**BOARD OF ZONING ADJUSTMENT
441 4th STREET N.W., SUITE 200S
WASHINGTON, DC 20011**

BZA No. 19067

APPELLANT’S SUPPLEMENTAL STATEMENT IN SUPPORT OF APPEAL

HOUSE RENOVATION
AND ADDITION
1117 ALLISON STREET N.W.

A3

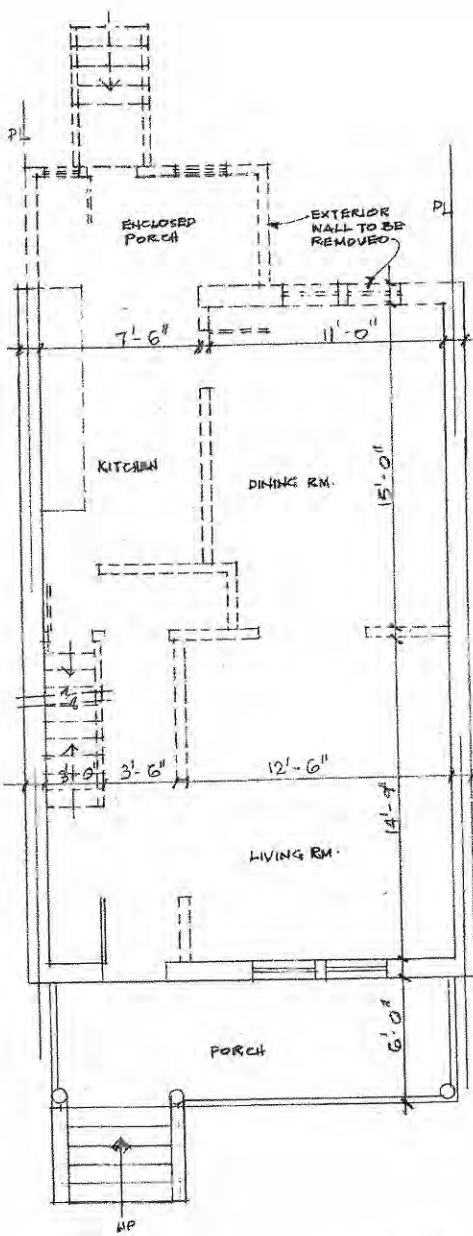
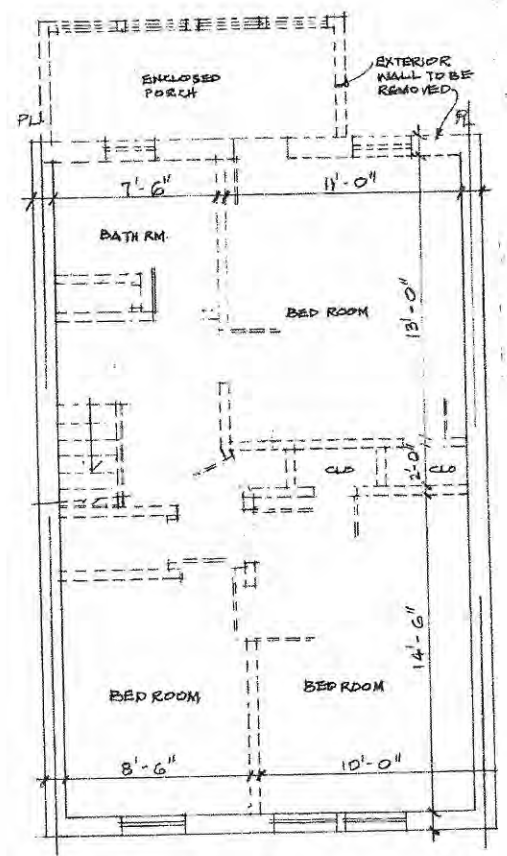
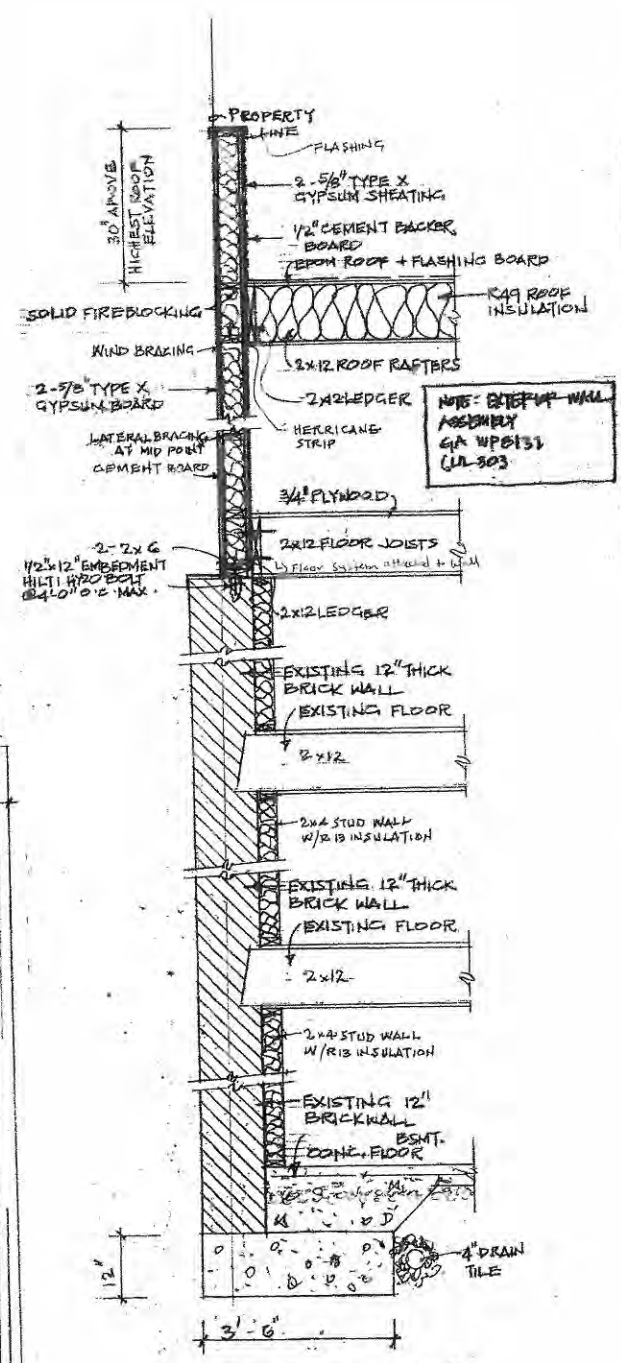
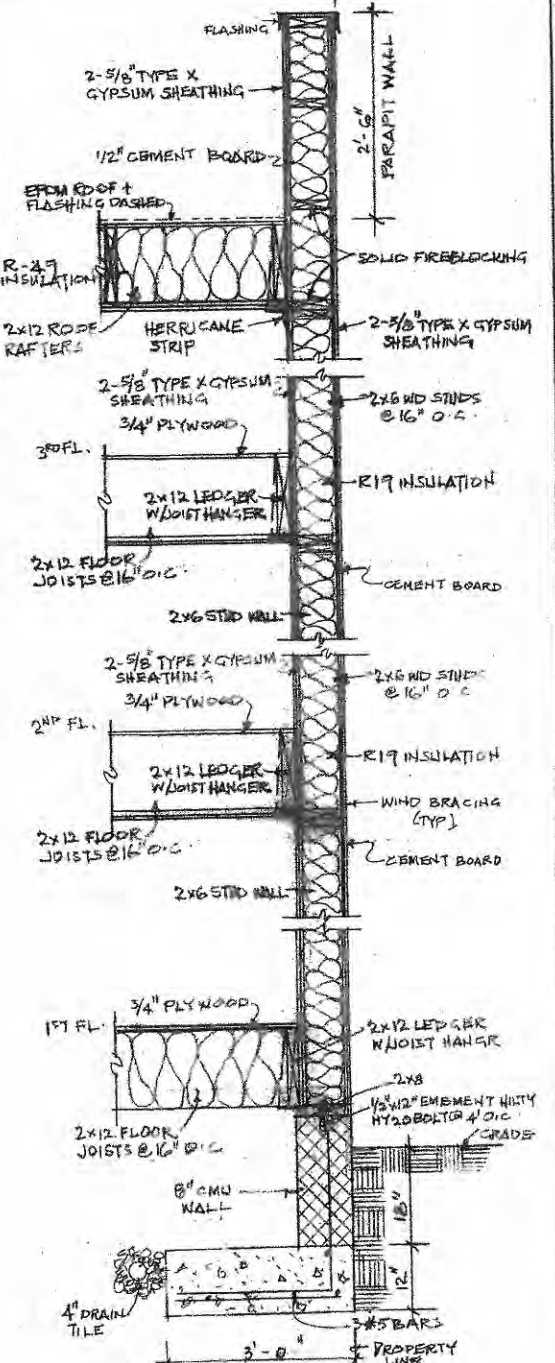
PEER REVIEW NOTE #3: In the revised Permit Set drawings (October 2015), Sheet A3 indicates that the front porch is to be demolished. However, on the previous Sheet A3 in the approved permit B1505734 (May 2015), the front porch was shown as existing to remain. Since, the previous Sheet A3 did not show the front porch as being removed but the new Sheet A3 does, this is essentially a material change in the revised Permit Set drawings (October 2015). Also, the existing front porch is in actuality at least 8 FT deep, not 6 FT as shown on Sheet A3.

ALLISON STREET, N.W.
EXISTING SITE PLAN
SCALE: 1"=20'

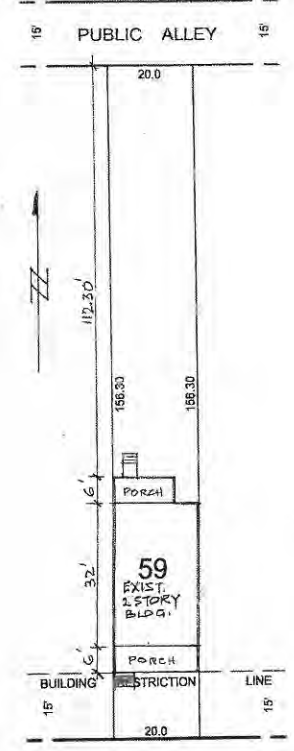
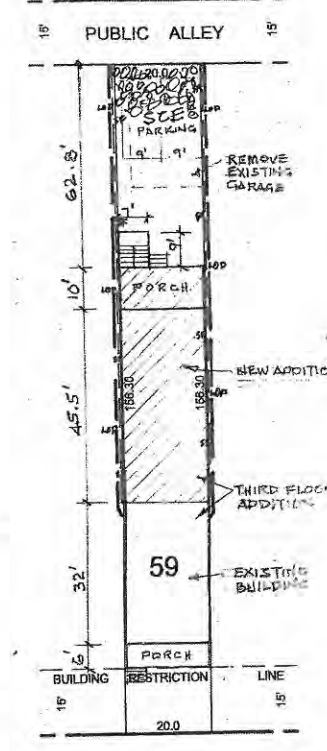
PEER REVIEW NOTE #2: Based on information provided and/or derived from Sheets C1 and C1-Copy In the revised Permit Set drawings (October 2015), the calculated percentage of pervious surface as proposed is 34.74%.

PEER REVIEW NOTE #4: In the previous Zoning & Building Code Peer Review Report dated April 27, 2015, dimension errors were identified on the Plat associated with the approved permit B1505734 (May 2015). Adjustments were needed regarding the 15 FT Building Reservation Line setback. The Plat drawings indicated on Sheets C1 and C1-Copy in the revised Permit Set drawings (October

2015) continue to have dimension errors. The 63 FT 9 5/8 inch dimension shown at the rear of the lot is not correct and should instead be 49.3 FT.
